# COMMENTS RECEIVED AND RESPONSES CONCERNING THE ENVIRONMENTAL ASSESSMENT WORKSHEET FOR

## Great Plains Sands Non-Metallic Mineral Mining Operation EAW Louisville and Sand Creek Township Scott County, Minnesota

Figure 1 Maximum Mining Depth, Minimum Mining Elevation.

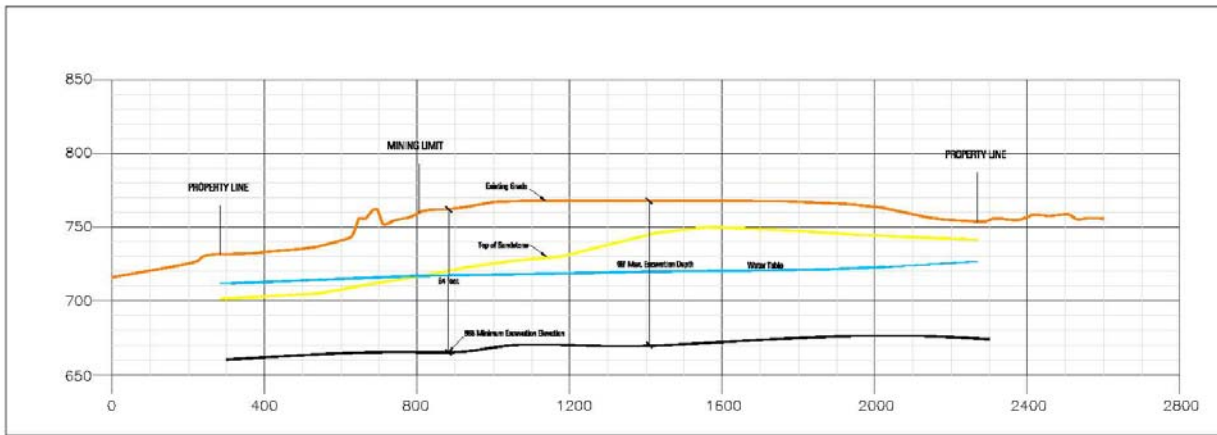
Item 4 states the average depth of the mining activity, but the minimum and maximum depth should also be included.

*Staff Response: The developer provided the following response to this comment: "Maximum Depth: The maximum depth of excavation will occur in the central portion of the site, which is a topographic high. In this location, there is approximately 23 feet of overburden, 26 feet of sandstone above the water table and 49 feet of mineable sandstone below the water table for a total maximum depth of excavation of 98 feet. This corresponds to an elevation of 670 feet above mean sea level (msl). The minimum excavation elevation will occur further to the northwest where there is approximately 40 feet of overburden removal, about 4 feet of sandstone removal above the water table and 50 feet of sandstone removal below the water table, for a total mining depth of approximately 94 feet. This corresponds to an elevation of 665 feet above mean sea level, approximately five feet above the bottom of the Jordan Sandstone. Because the existing grade, the top of sandstone and bottom of mineable sandstone elevations all vary across the Site, the depth of mining will vary across the Site. Figure 1 illustrates the two scenarios described above.*

The minimum depth of mining is zero feet in areas of the site that will not be mined or used for stormwater management. This includes approximately 4 acres in the southwestern portion of the Site.”

INTERIM MINING SLOPES ALONG EASTERN SETBACK AREA

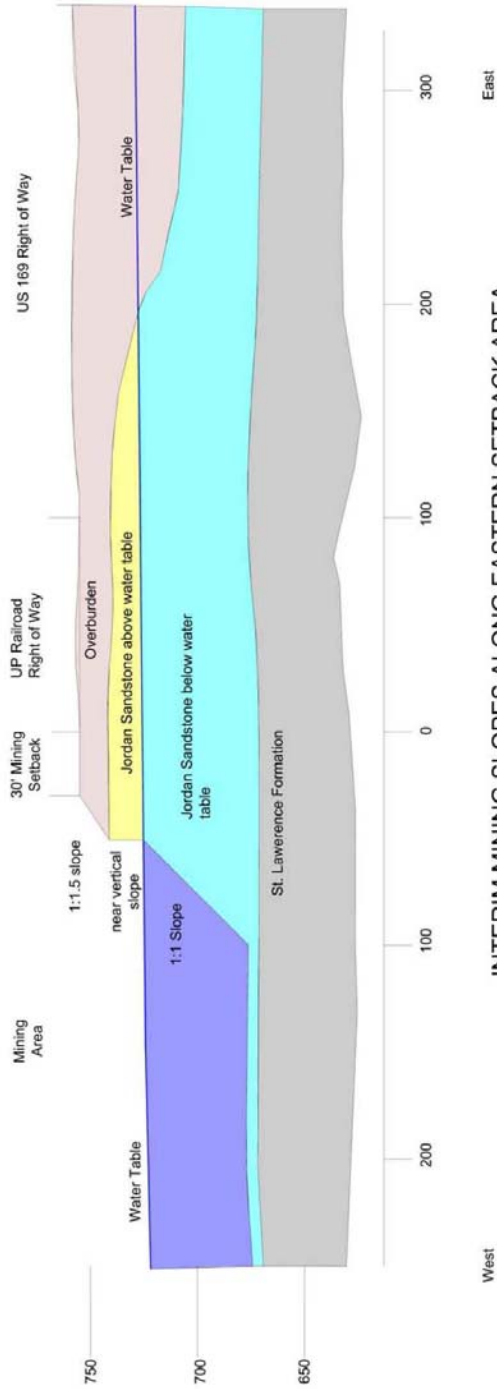
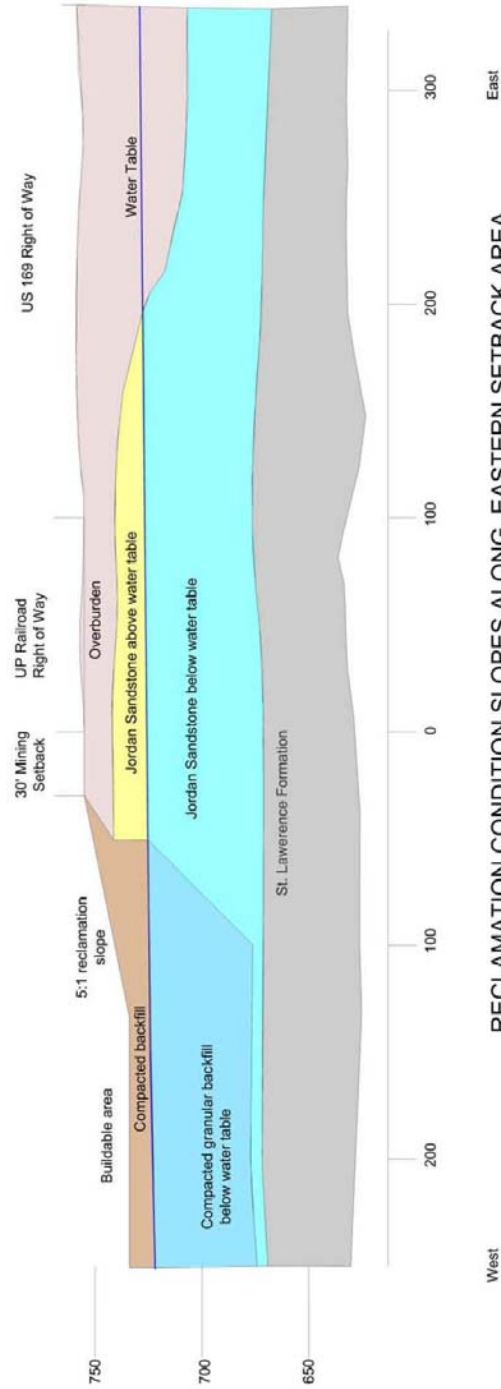
Page 8 states that mining will occur within 30 feet of rights of ways. Information on depth and slopes of excavation in these areas needs to be provided.

*Staff Response:* The developer provided the following response to this comment: Mining is proposed to be conducted to within thirty feet of right-of-ways as allowed by ordinance. Along the west side of the property, this boundary is a railroad right of way. Excavation slopes along the railroad right of way setback will include an approximately 1.5:1 excavation slope in the overburden, a near vertical wall in the sandstone above the water table, a 2:1 excavation slope in the sandstone below the water table and a 5:1 upland reclamation slope. Along the eastern setback line a typical excavation section will be approximately 14’ of overburden, 16’ of sandstone wall above the water table, and 40-50 feet of mining below the water table. Figure 2A illustrates the excavation slopes during the interim mining condition along the eastern boundary of the property with respect to the railroad and US 169 rights of way. Figure 2B illustrates the slopes across this same section upon reclamation. These slopes are approximate only and are expected to vary somewhat throughout the mining area depending upon the nature of the material encountered in the overburden as well as the nature of the sandstone itself. Highly consolidated and cemented layers encountered throughout the formation will impact the actual mining slopes both above and below the water table.

Mining limits are setback over 350 feet from the western property line right-of-way of the UP railroad running along the western boundary of the Site due to the absence of mineable Jordan along the western edge of the property.

portion of the southern right of way setback. Past mining and reclamation has occurred in this area. There will be an excavation slope of approximately 1.5:1 along this entire setback to the reclamation grade but not below the water table, until the eastern portion where the sandstone picks up. In this eastern area of the southern boundary, along the road-right-of way, the setback will include an approximately 1.5:1 excavation slope in the overburden, a near vertical wall in the sandstone above the water table, a 2:1 excavation slope in the sandstone below the water table and a 5:1 reclamation slope. Figure 3 A,
